DEPARTMENT OF THE ARMY

May 17, 2013

Re: Proposed Test Pit Investigation Plan for Parcel 28 Historical Septic Tank Systems and Gas Station, Charles Wood Area, Fort Monmouth, New Jersey

FIGURE 2 June 30, 1944 Hand-Drawn Sketch of the Charles Wood Area

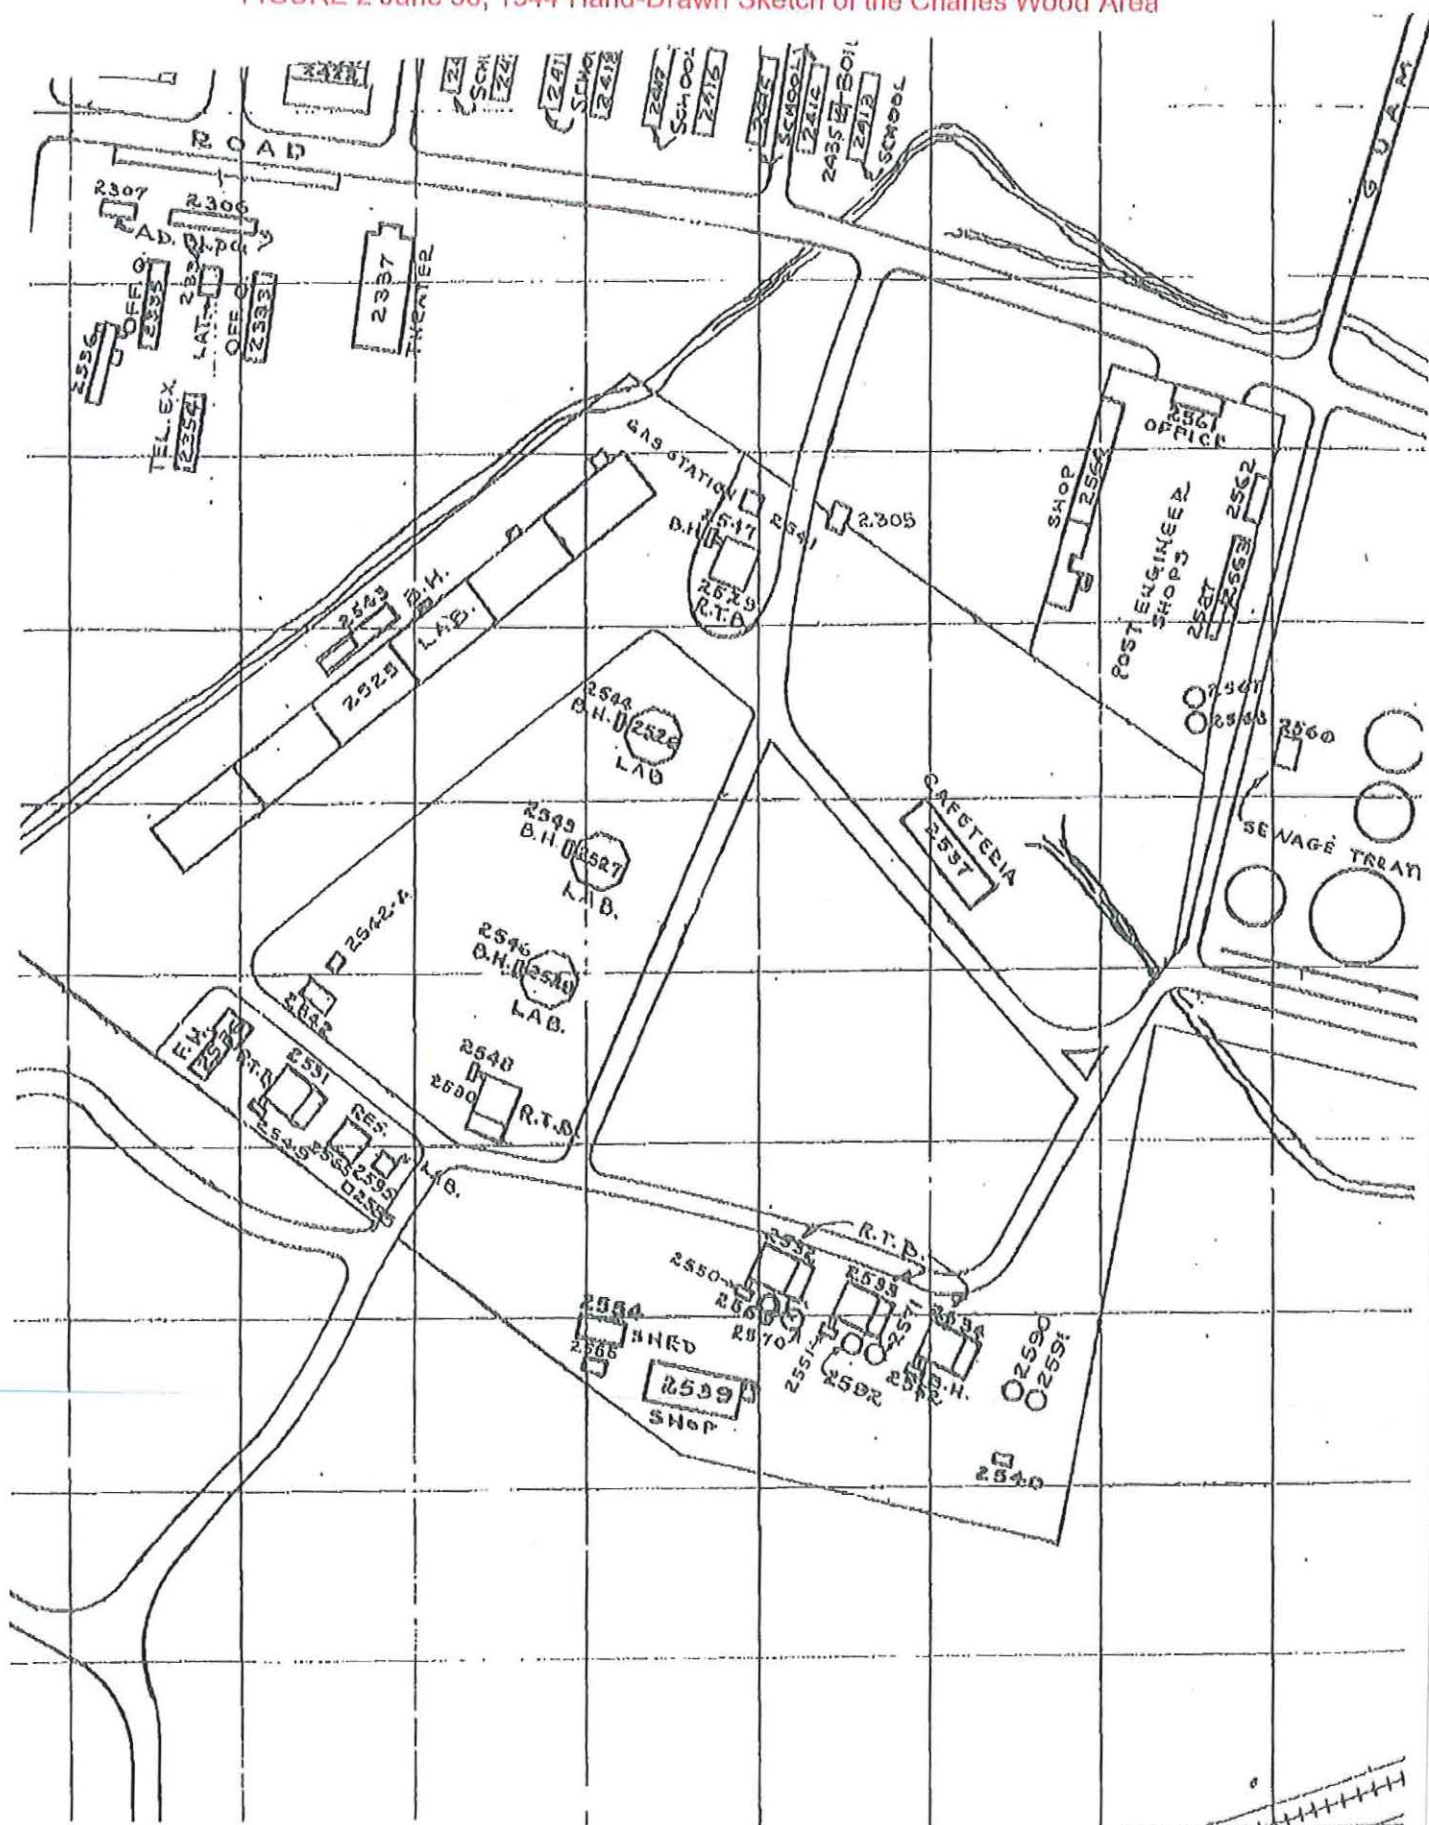
According to a June 30, 1944 hand-drawn sketch of the Charles Wood Area (**Figure 2**), former building 2541 is depicted as "gas station". The structure depicted as a gas station on the sketch is also present on a May 2, 1957 aerial photograph (**Figure 3**) of the area. In a subsequent May 13, 1963 aerial photograph (**Figure 4**), the "gas station" structure is no longer present. No other records regarding former building 2541 could be found. The Army believes the former Bldg. 2541 gas station depicted on the sketch and aerial photographs was demolished during renovation/reconfiguration of the Charles Wood Area, circa 1957-1963. The building number 2541 has since been reused, and is currently the building number of a warehouse at the Charles Wood Area.

In an effort to determine if any remnants of the gas station remain, including any underground storage tanks, piping, and any historical discharge that may have occurred, the Army proposes to

dig five test pits to the depth of the groundwater table in the area where the former gas station was located. Excavated soil from each test pit will be visually examined and scanned with a photoionization detector. If visually stained soil or soil with field-detectable volatile organic compounds are encountered at a test pit location, three samples will be collected: a soil sample from the impacted area, a soil sample within six inches of the groundwater table, and a groundwater sample. If no impacted soil is encountered, only two samples will be collected: a soil sample within six inches of the groundwater table and a groundwater sample. All samples will be submitted to an NJDEP-certified laboratory and analyzed for volatile organic compounds with a library search of the fifteen highest tentatively identified compounds (VO+15) plus lead. If any underground storage tanks or piping are encountered, these items will be removed from the subsurface with soil and groundwater sampling conducted in accordance with N.J.A.C. 7:26E and the regulations regarding closure of a UST system N.J.A.C. 7:14B). A summary report detailing the findings of the test pit investigation, including all photodocumentation, will be submitted to the NJDEP.
